ROUTE 7 CORRIDOR IMPROVEMENTS

State Project Nos.: 0007-029-942 and 0007-028-225
Federal Project Nos: STP-5A01(745) and STP-5A01(790)
Contract ID No.: C00099478DB98

VOLUME I: REVISED TECHNICAL PROPOSAL

Summary of Changes

STATE	ROUTE	STATE PROJECT	SHEET NO.
VA.	7	0007-029-225 P101, R201, C501 0007-029-942 P101, R201, C501	15

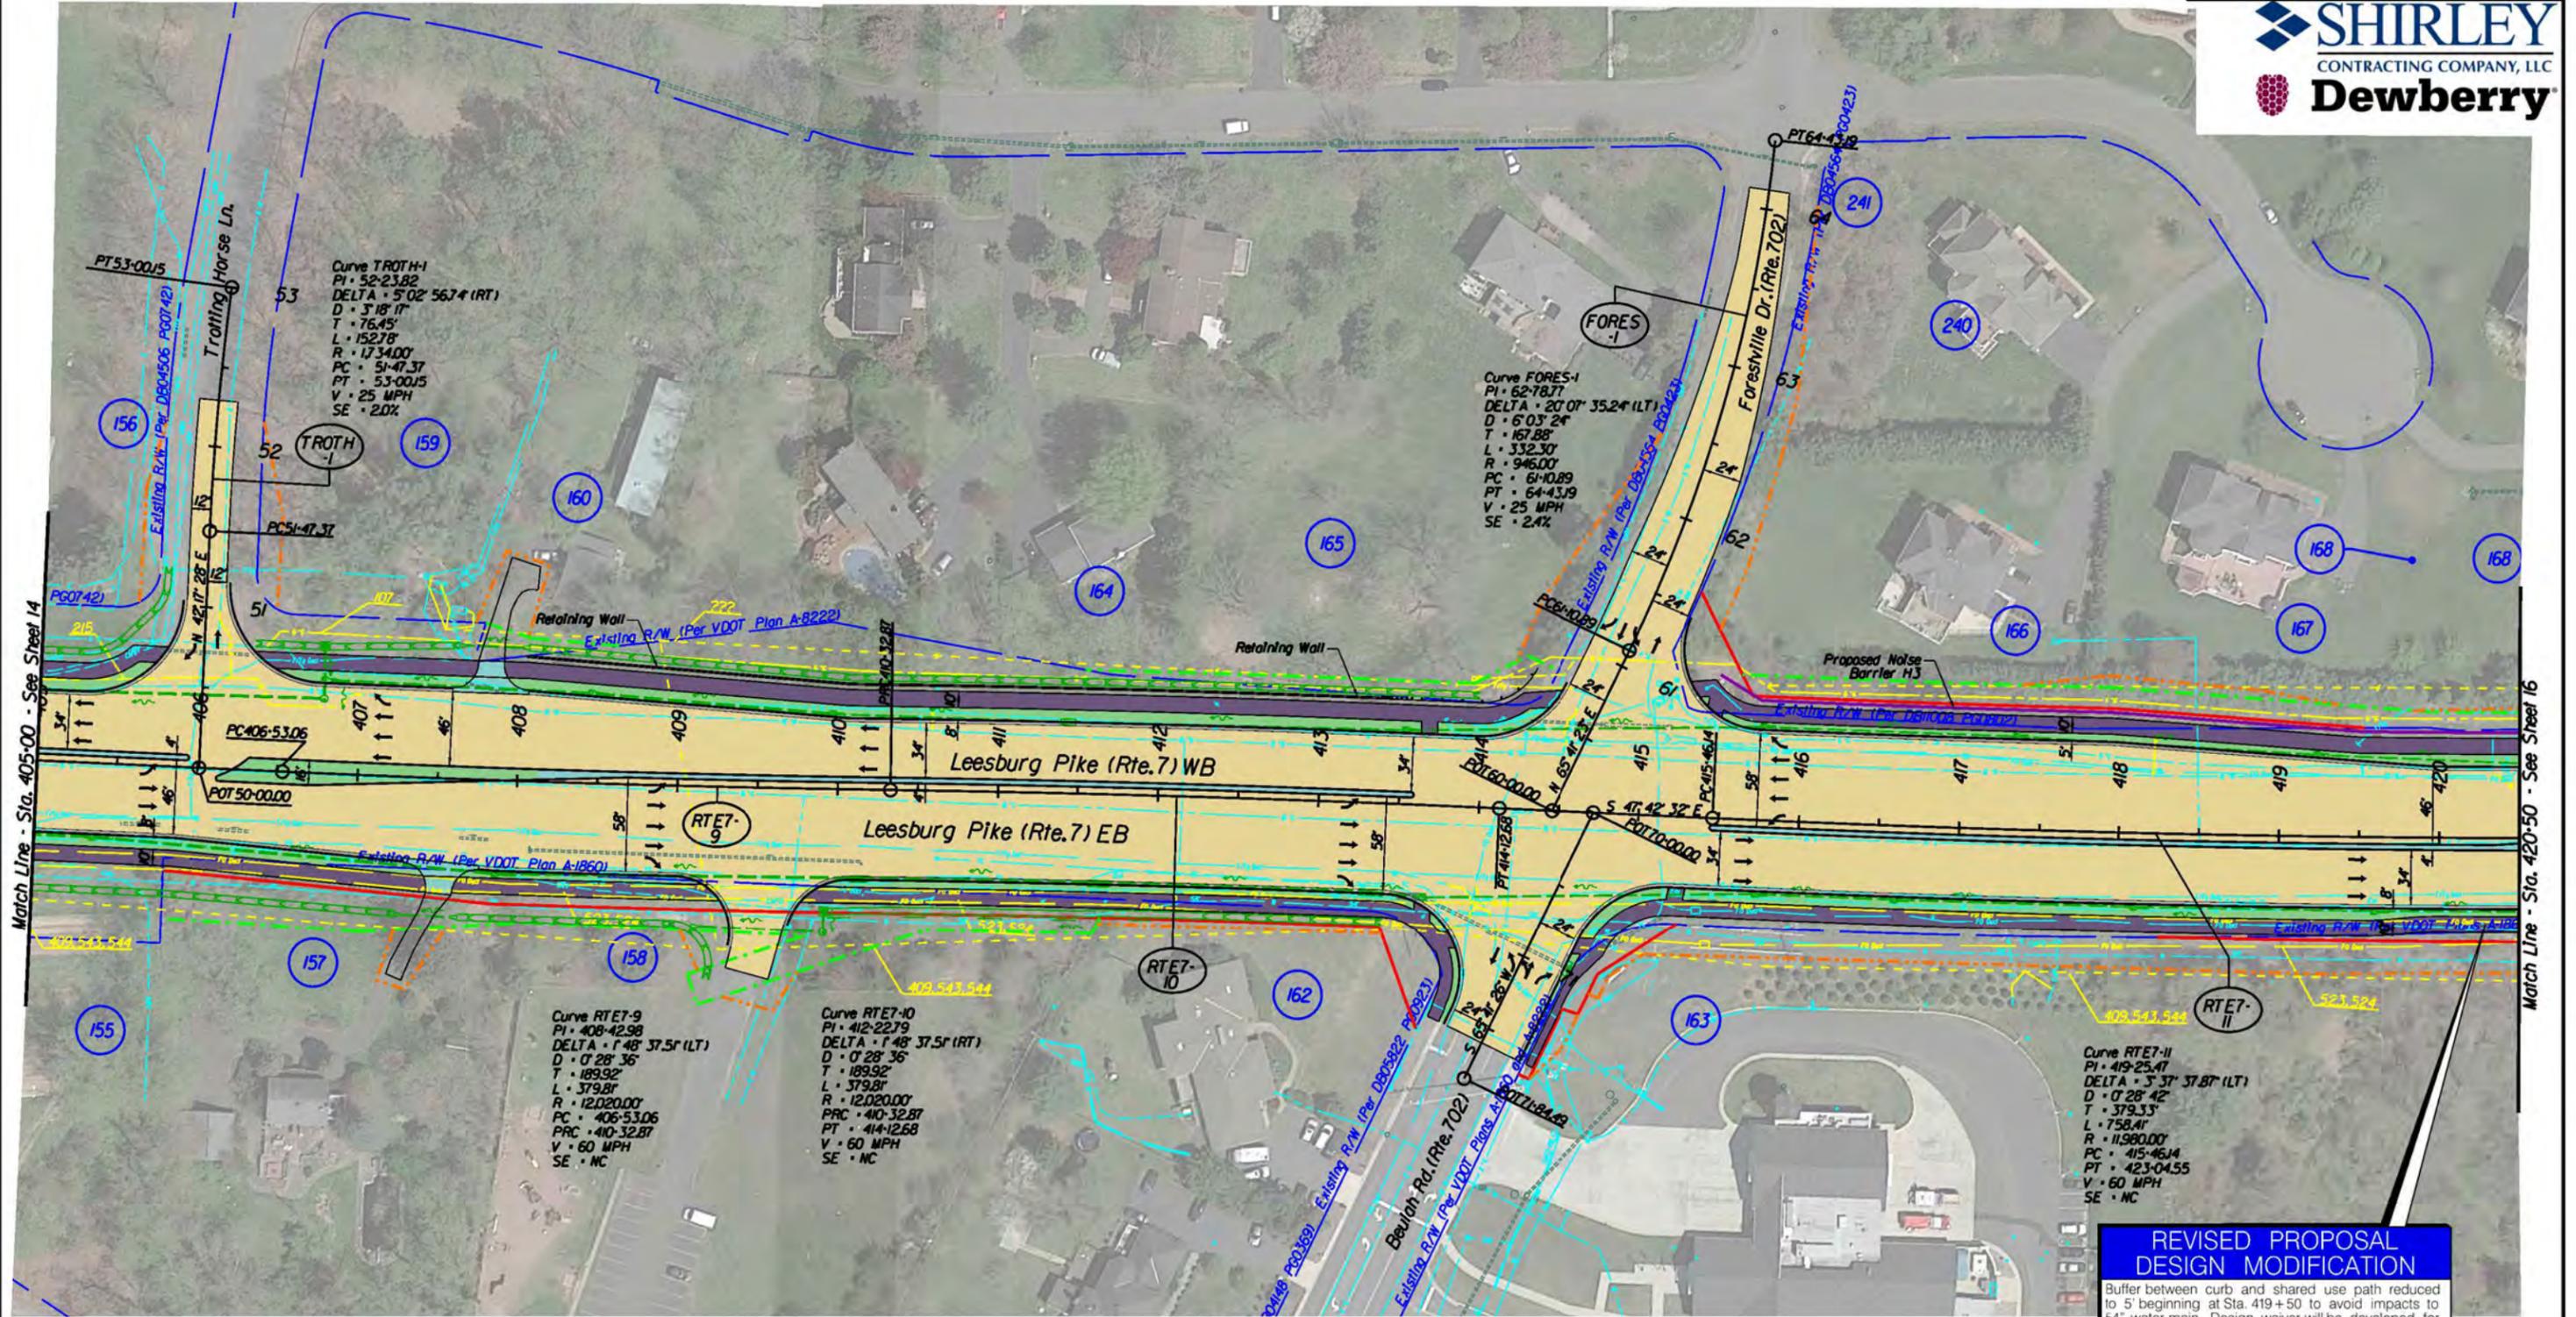
REVISED PROPOSAL DESIGN MODIFICATION
 Buffer between curb and shared use path reduced to 5' beginning at Sta. 419+50 to avoid impacts to 54" water main. Design waiver will be developed for approval by VDOT.

STATE	ROUTE	STATE PROJECT	SHEET NO.
VA.	7	0007-029-225 P101, R201, C501 0007-029-942 P101, R201, C501	16

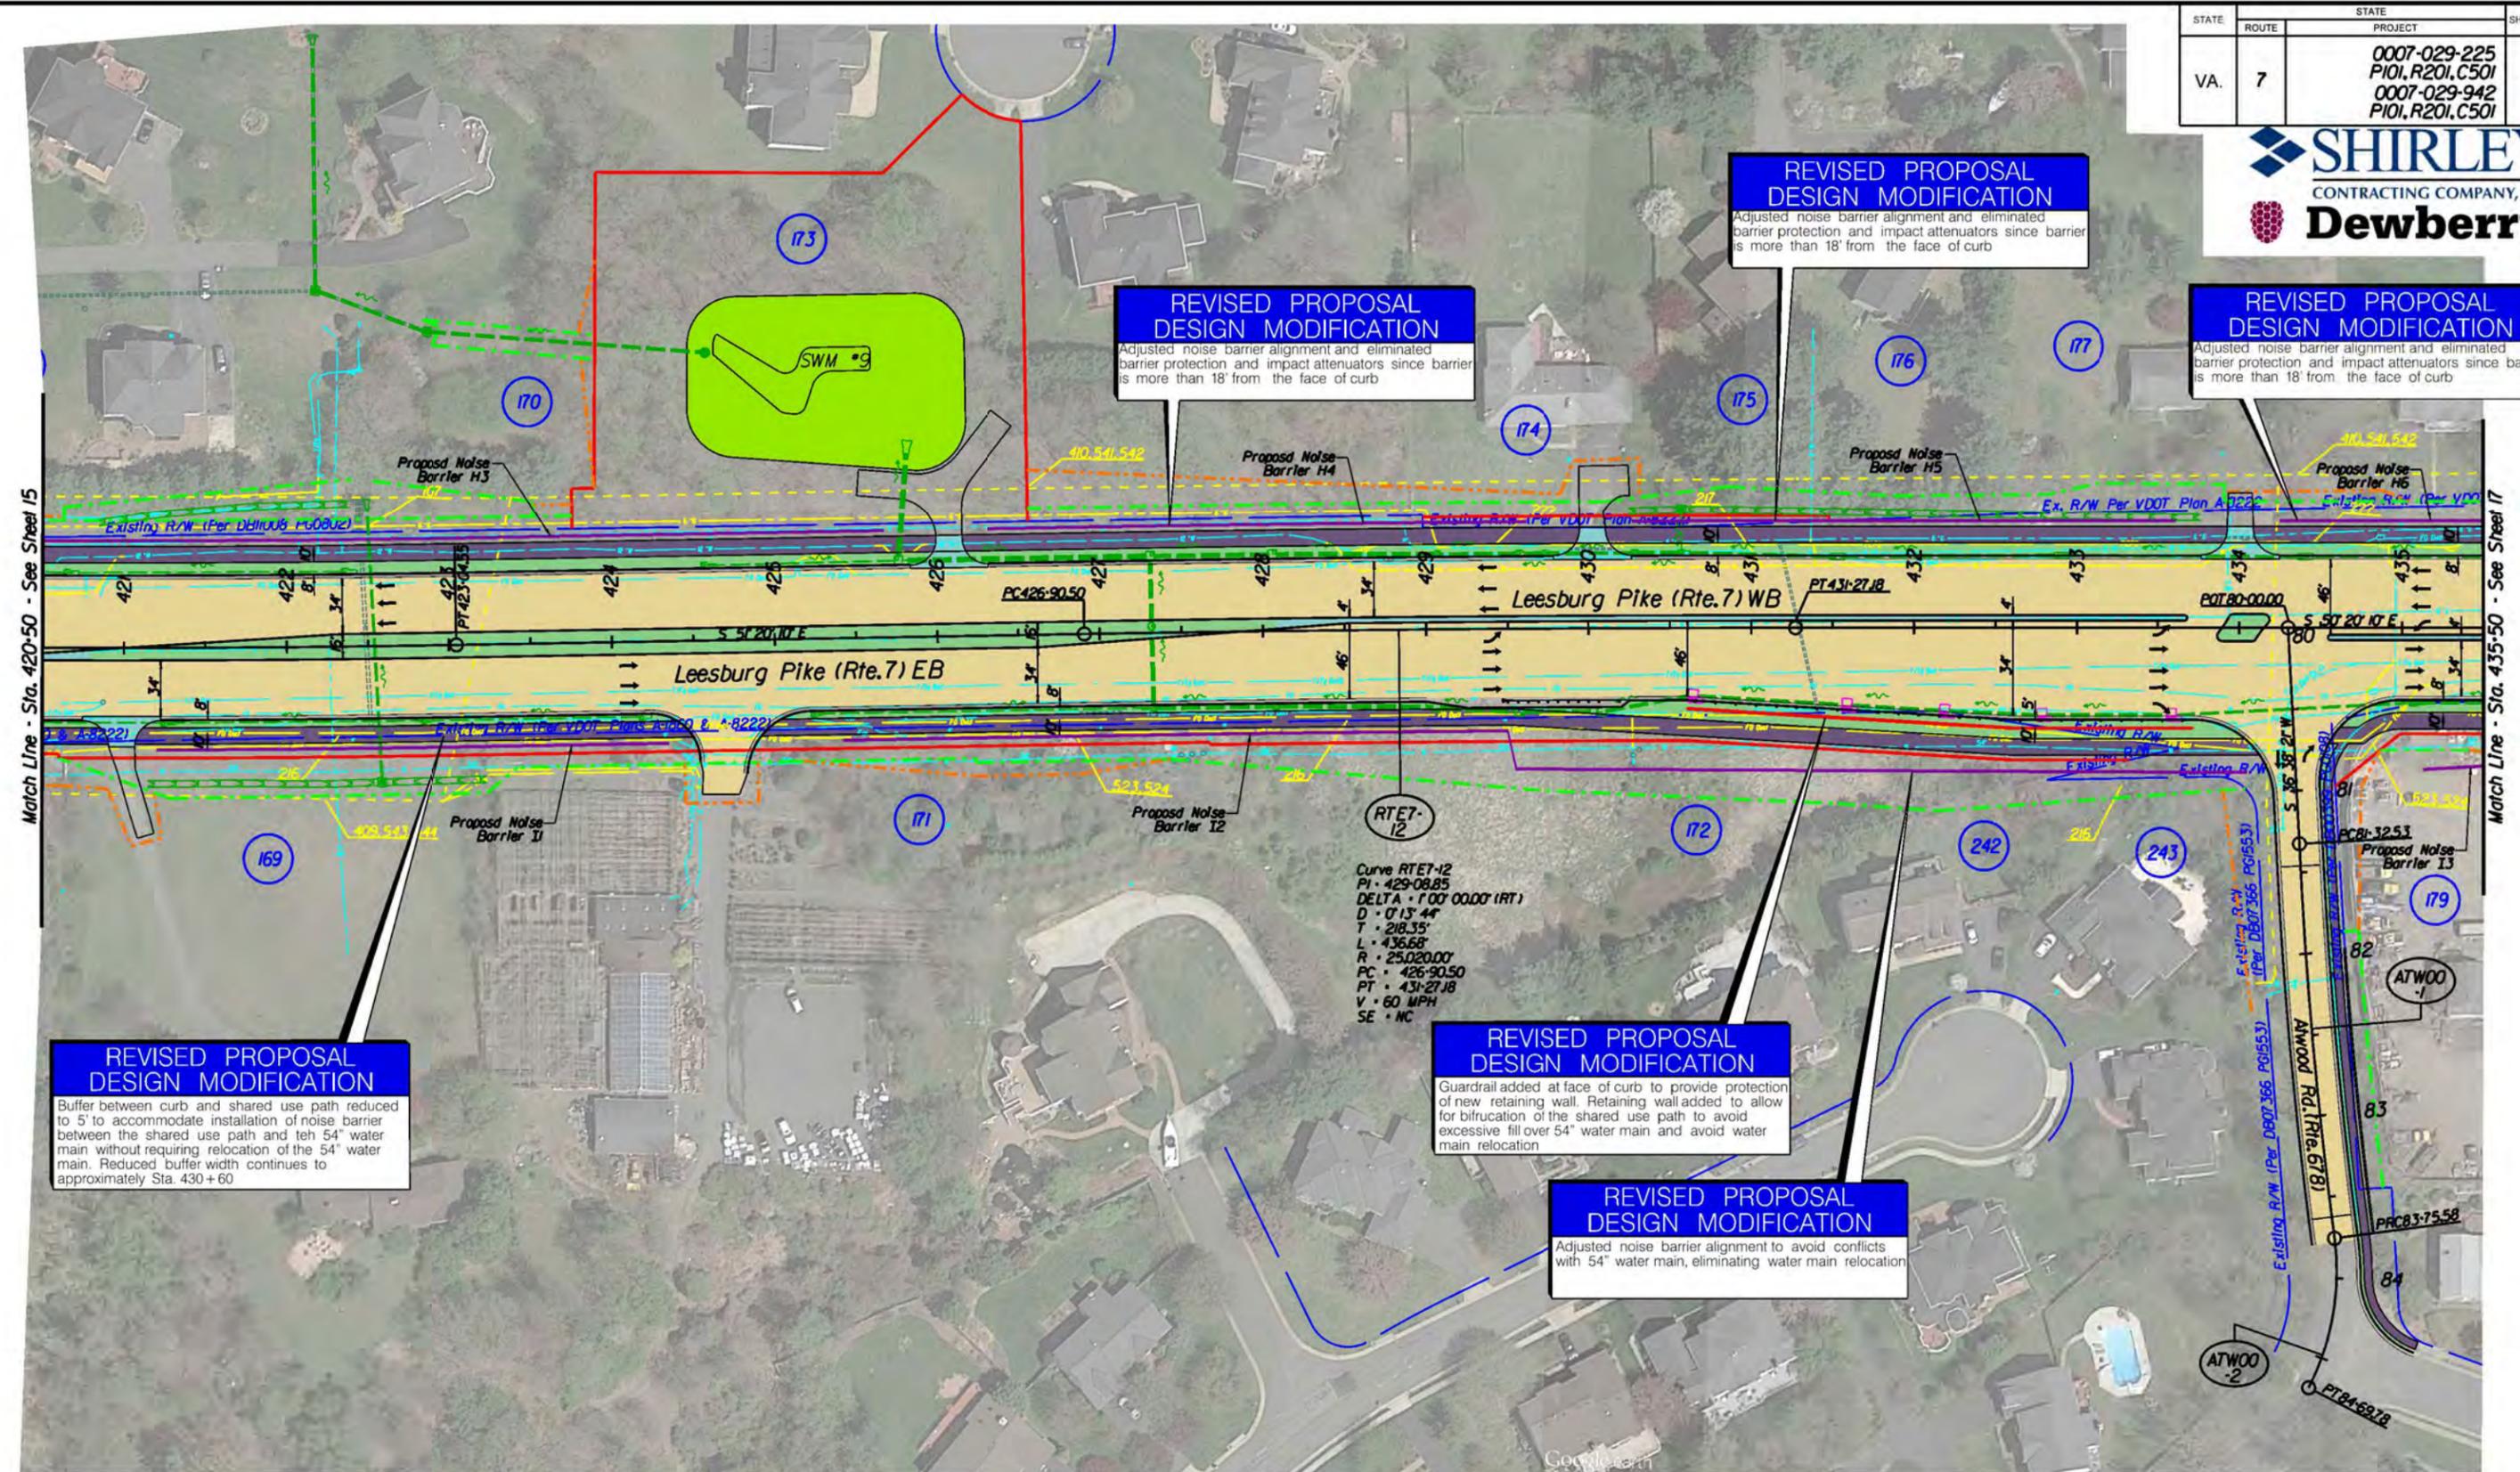
REVISED PROPOSAL DESIGN MODIFICATION
Adjusted noise barrier alignment and eliminated barrier protection and impact attenuators since barrier is more than 18' from the face of curb

STATE	ROUTE	STATE PROJECT	SHEET NO.
VA.	7	0007-029-225 P101, R201, C501 0007-029-942 P101, R201, C501	17

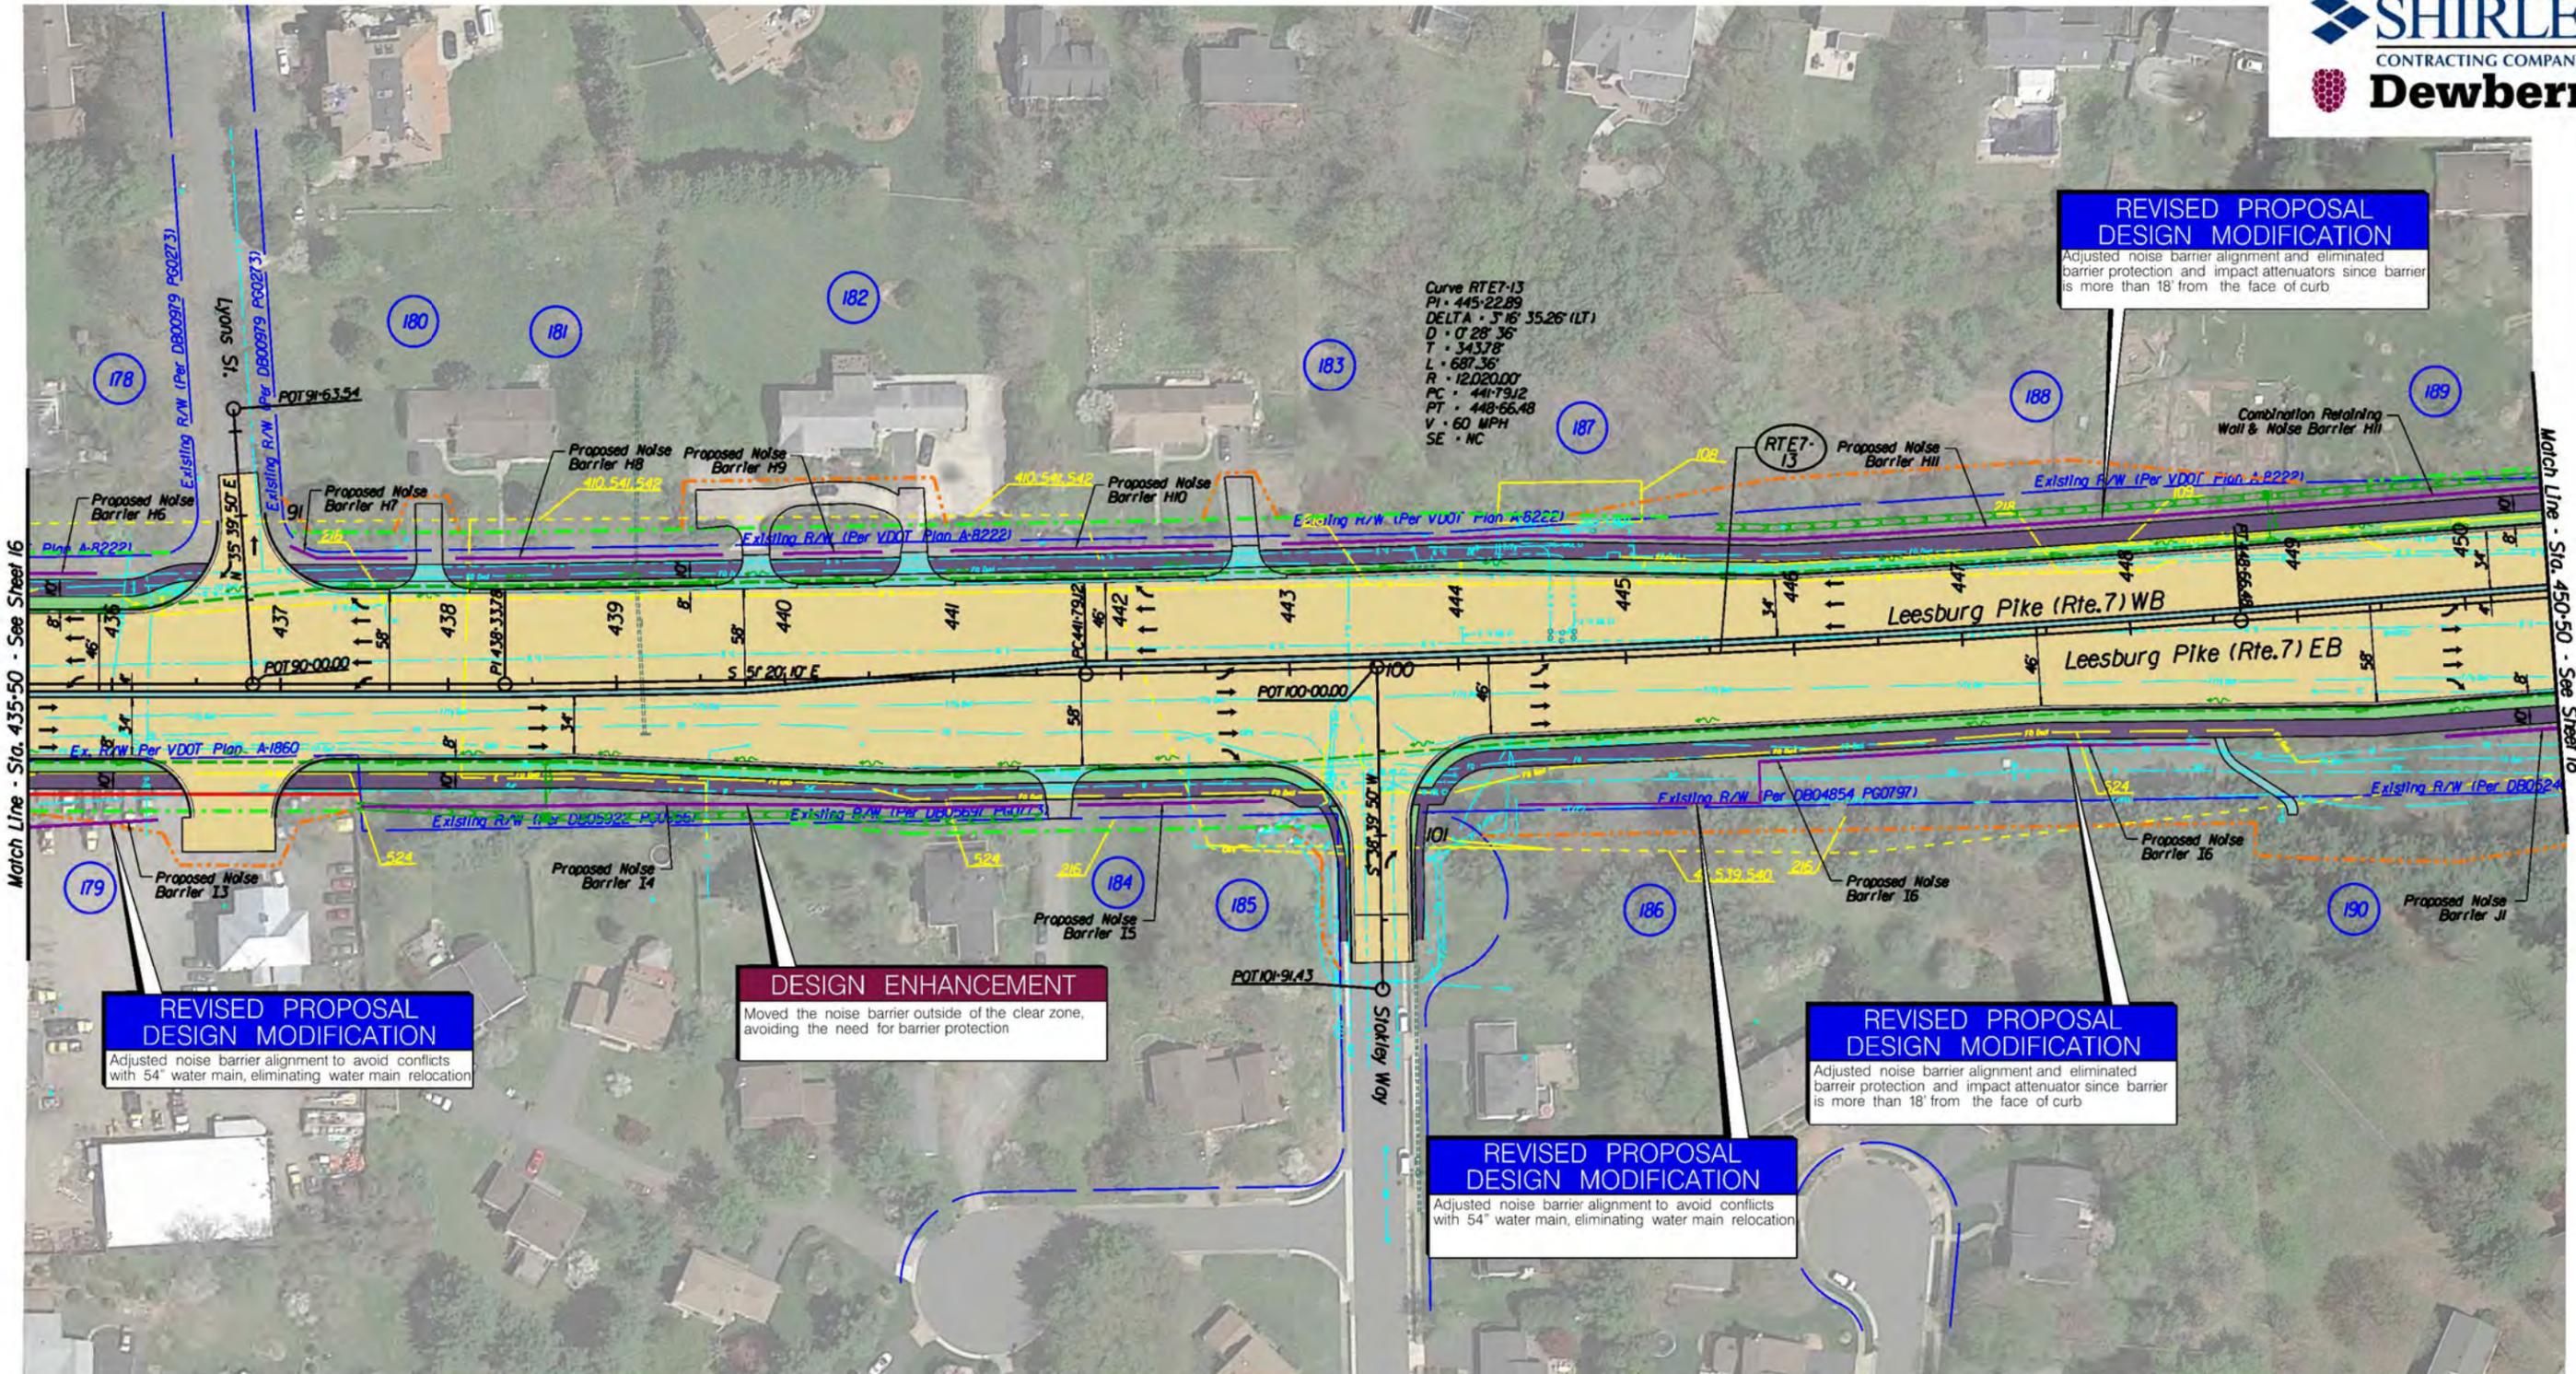
REVISED PROPOSAL DESIGN MODIFICATION
Adjusted noise barrier alignment and eliminated barrier protection and impact attenuators since barrier is more than 18' from the face of curb
